ADDENDUM

AD #4

Project **West Point Dairy - Hyrum - Storage Warehouse**
Project No. **250429500**
Location **Hyrum, Utah**
Date **August 21, 2026**

STORAGE WAREHOUSE EXPANSION FOR:
WEST POINT DAIRY PRODUCTS

GENERAL PROJECT PHASING PLAN

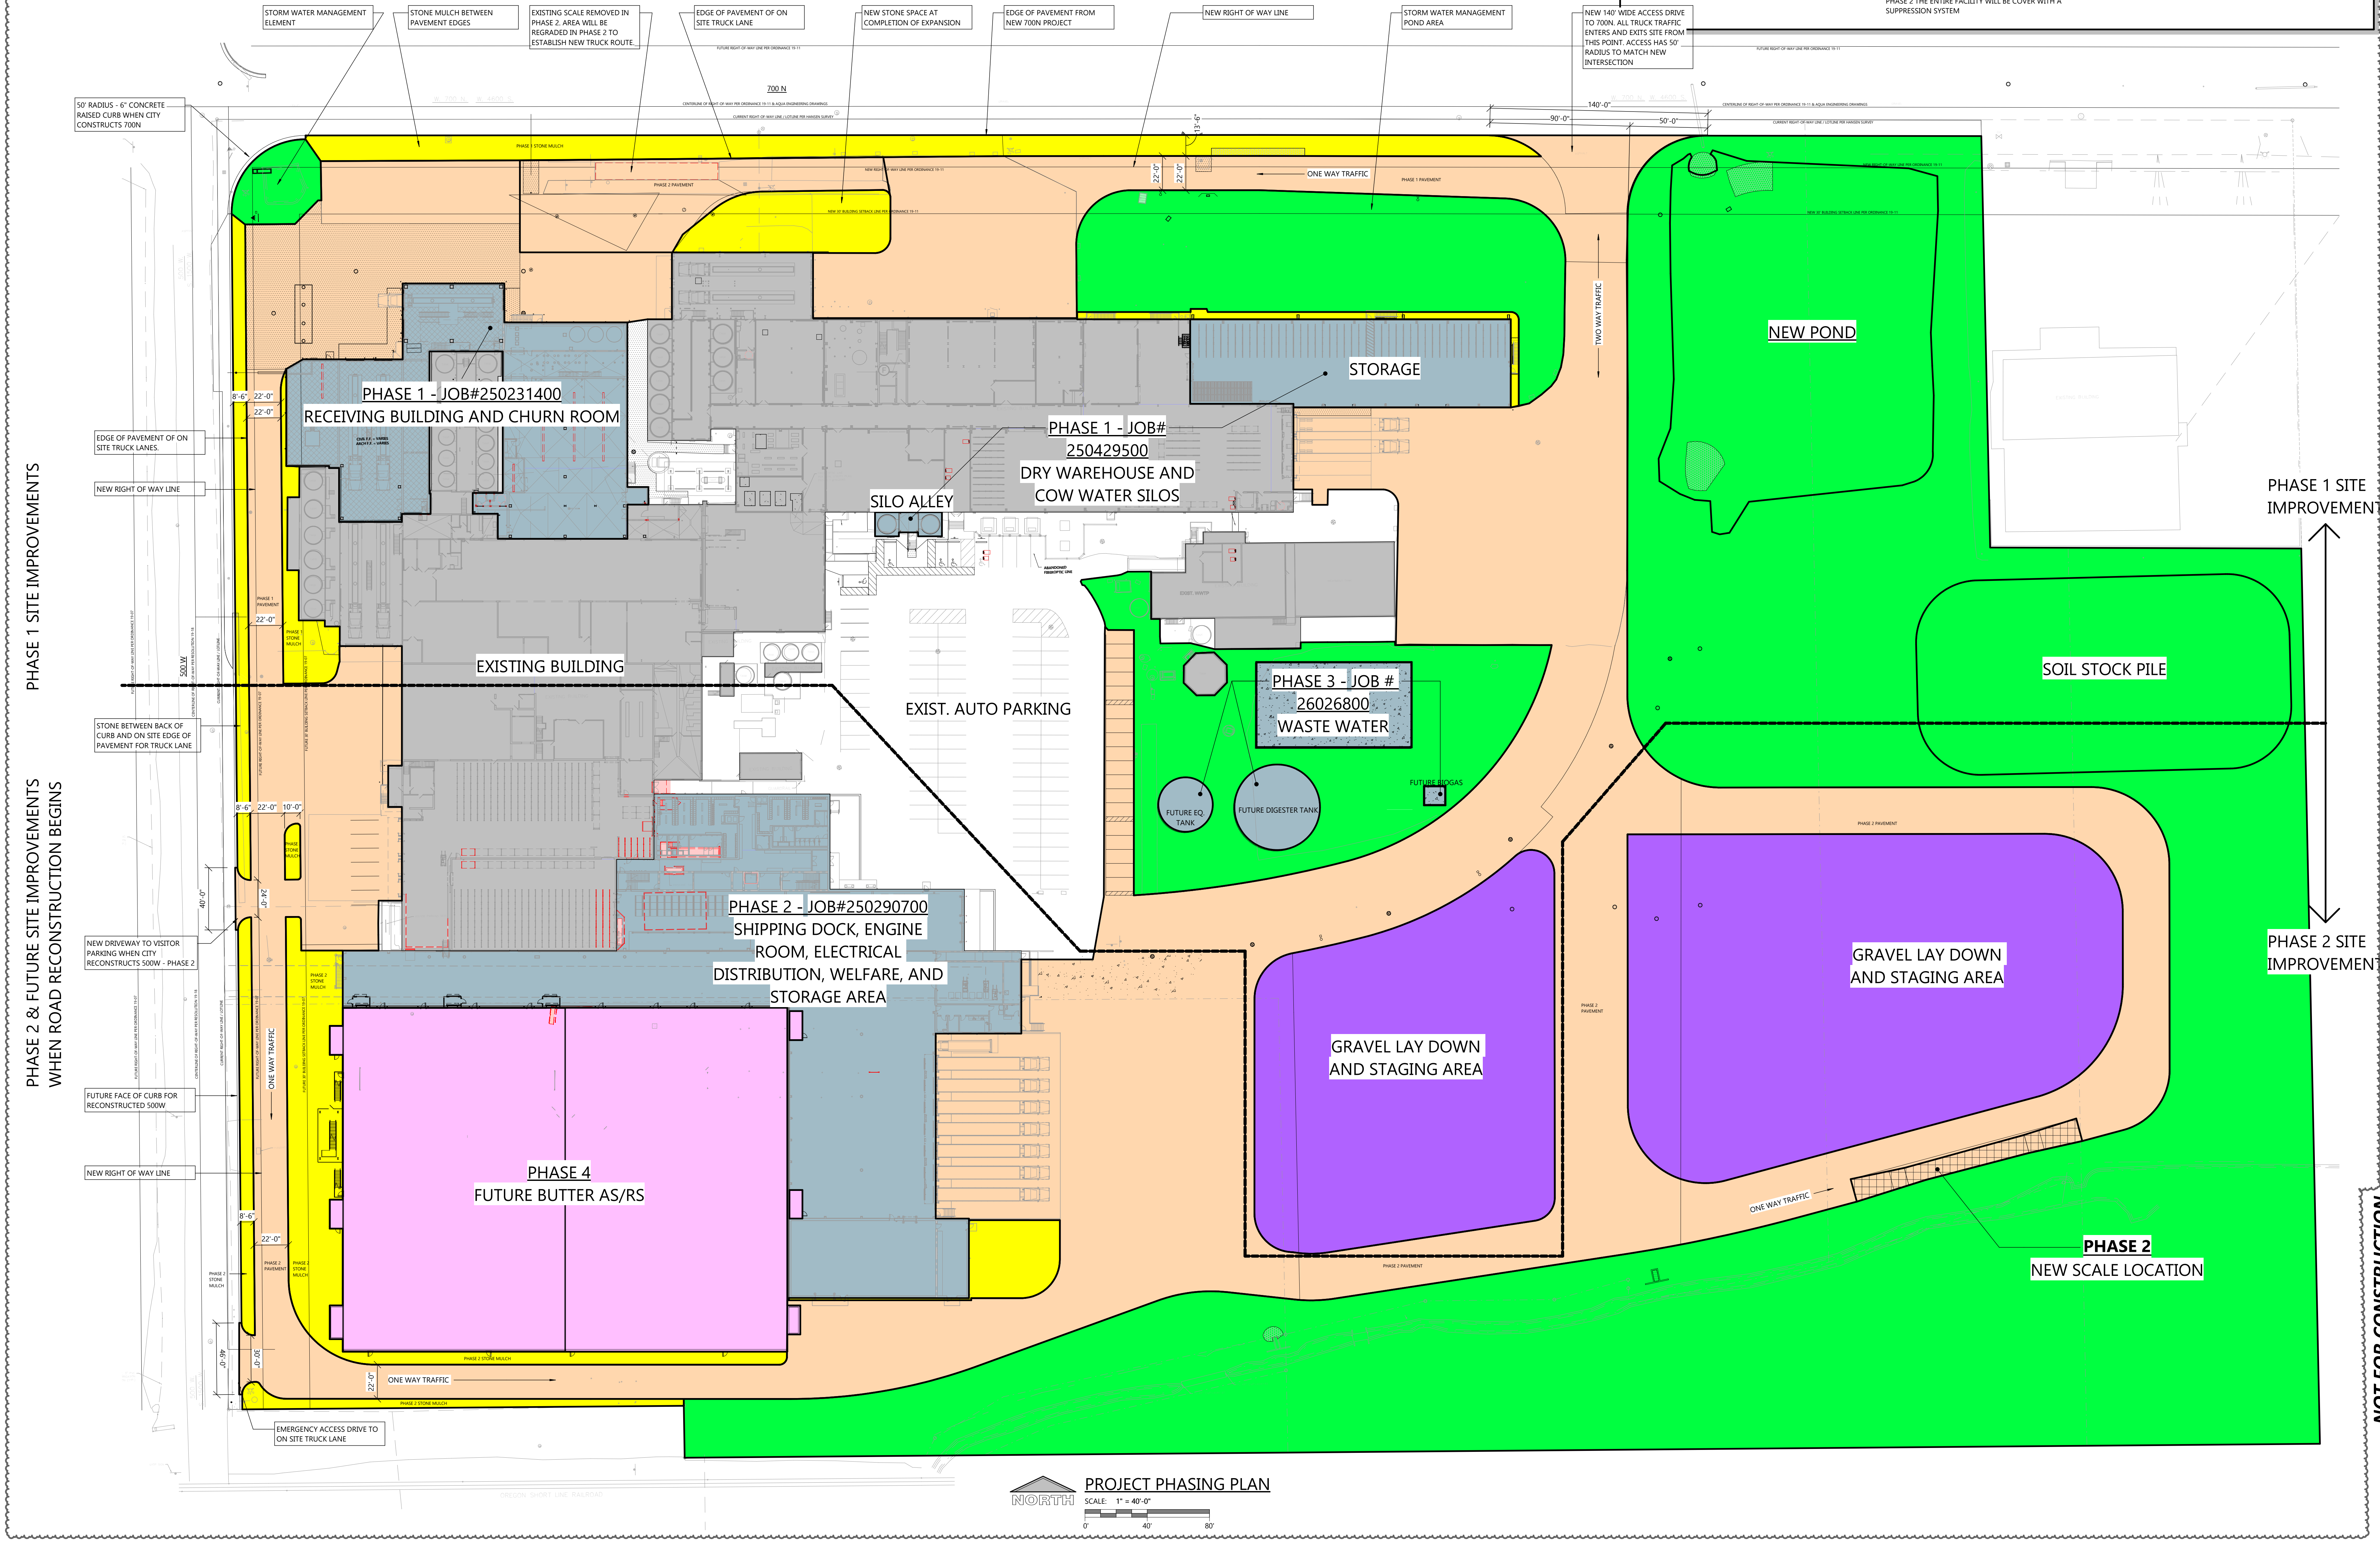
T1.0	Updated sheet index.
T1.1	Updated future project footprints.
	Updated Square footages.
T1.1PH	Updated Sheet.
A1.0	Updated future project footprints
S2.4	Updated top plate of silo embed ring to stainless steel
E1.1AL	Added circuit tags to emergency exit signs.
